Program Review of the Implementation of Approximate Original Contour Regulations in Pennsylvania's Bituminous Surface Mining Program

Harrisburg Field Office

September 2010

Figure 37

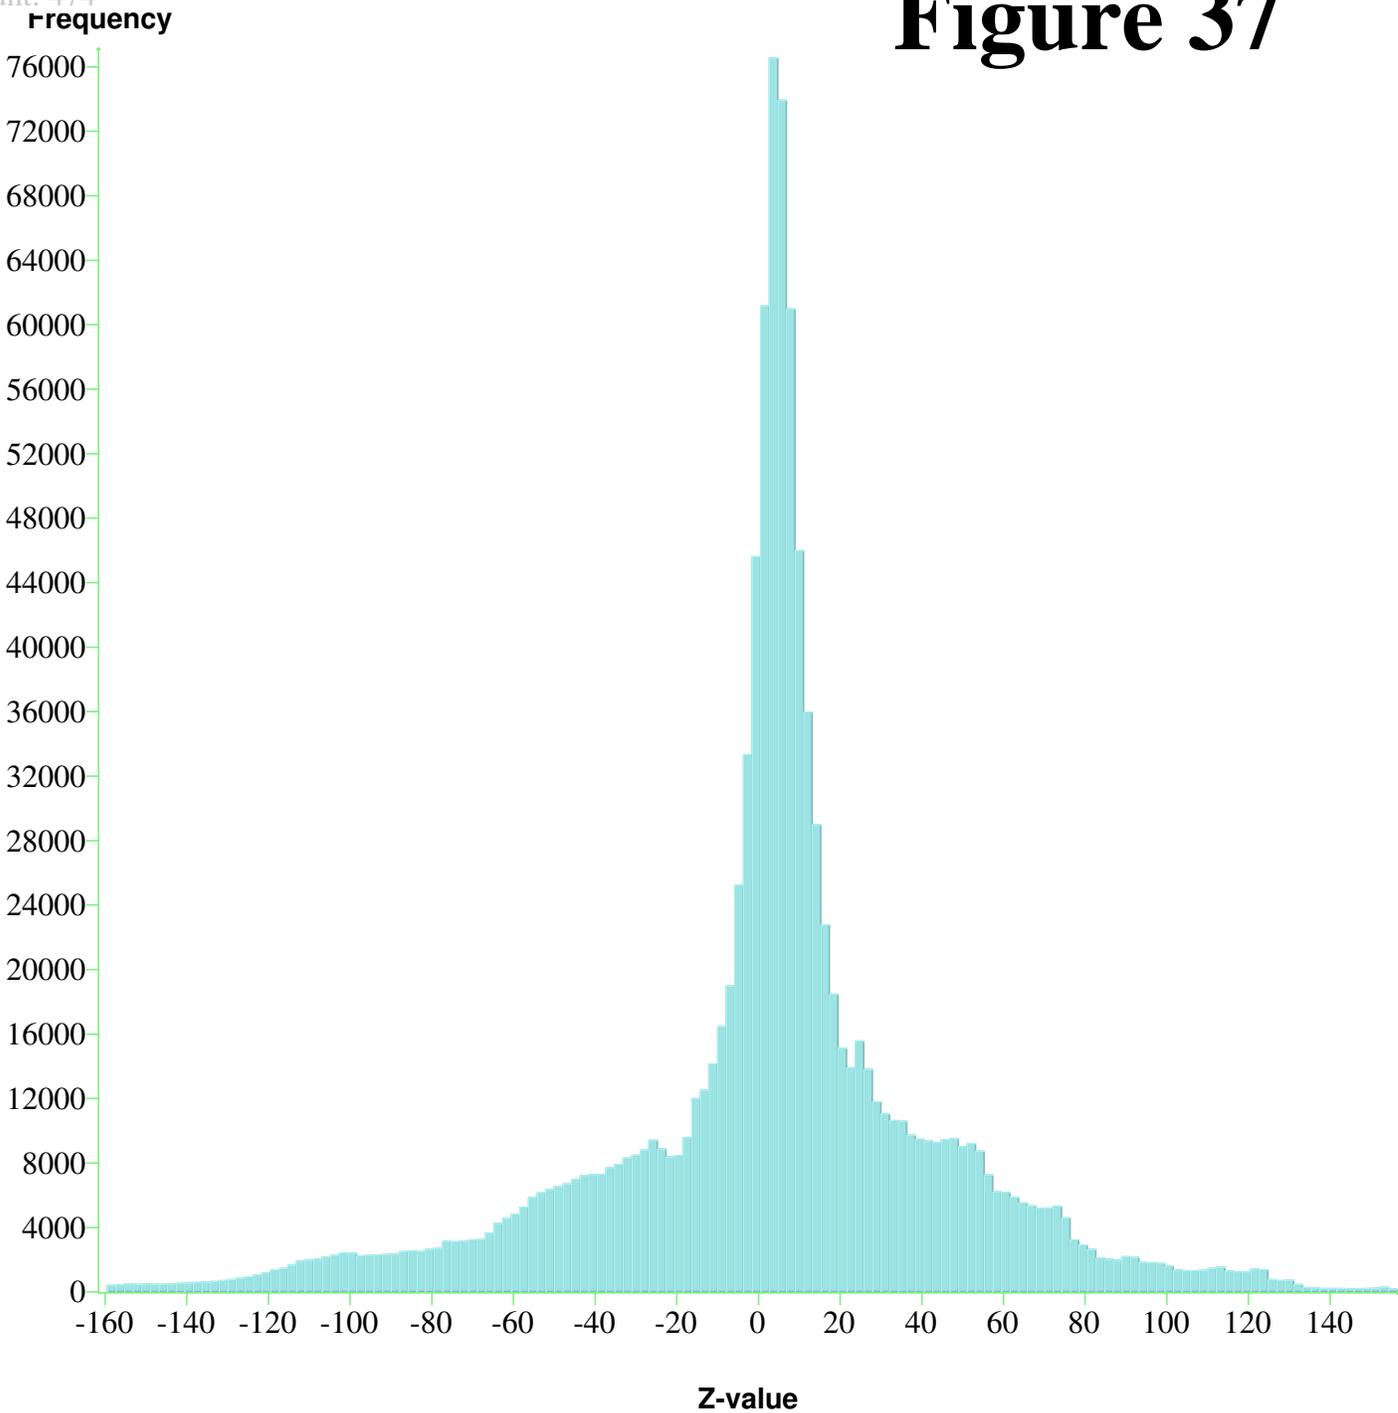
elevation in all but the western side of the permit. Figure 37 is a histogram of the elevation-difference data used to create the elevation-difference map in Figure 31. The histogram shows that, of the 1.1 million elevation-difference data points, 25% of the mine site was reclaimed to within 10.5 ft and 75% of the site was reclaimed to within 19.4 ft of the original area. These statistics include the changes in the remaining topography. This analysis shows that a large difference between pre and post-mining elevations is confined to the western portion of the permit where mining last occurred. It's fairly clear that the change in operational plan (less spoil) coupled with the remaining obligation to reclaim the large pits resulted in a spoil deficiency situation in the last mining area. Cross section BB shown in Figure 33 illustrates the issue. The location of cross section BB is shown in Figure 31. In the eastern section of the cross section, the reclamation was very consistent with the approved reclamation plan. The eastern-most hill top was lowered by approximately 40 ft, which is consistent with the approved reclamation plan. However, as the mining plan changed as the mining progressed toward the west, the reclamation surface started to drastically differ from the approved reclamation topography. A revised reclamation plan should have been submitted as the mining operation deviated from the approved mining plan. Therefore, the surface owners still thought the approved reclamation plan was being implemented and never had an opportunity to review or comment on how the change in operations would affect the reclamation of their property. There is no evidence that the property owners or DEP were aware that the surface elevation would be lowered by 160 ft in the western part of the permit. With that said, there were no objections to Stage I bond release and DEP concluded the site achieved AOC. Moreover, the OSM site inspection used the same field techniques as the DEP inspectors to evaluate AOC. The OSM site inspection was completed before any knowledge of the results of the quantitative analysis. OSM performed a visual comparison of the reclamation map to the site reclamation and noted differences between the two but did not identify the lowering of the western-most hill top by 160 ft. The permit stated that the western-most slope would be reduced to a gentler grade, but the lowering of the hill top was not obvious in the field. A visual observation of the reclaimed land surface shown in Figure 30 shows a "natural-looking" land surface and the loss of 160 ft in elevation in the western portion of the permit is not obvious without close examination. The reclamation blended into the surrounding topography and without a point of known elevation to reference, the reduction in elevation was not apparent in the field. There are very few ridge mines in the bituminous region of Pennsylvania. Most mining operations are contour strip or box cut. Achieving AOC is much easier with those mining methods as the operator is likely to achieve AOC by just regrading to the original unmined ground at the top of the high wall and the bottom of the low wall. Achieving AOC in a ridge operation is more difficult. If the entire ridge is mined, there are no unmined areas left on top of the hill that can be used as a point of reclamation reference. Since DEP's current definition for AOC only includes qualitative metrics, neither
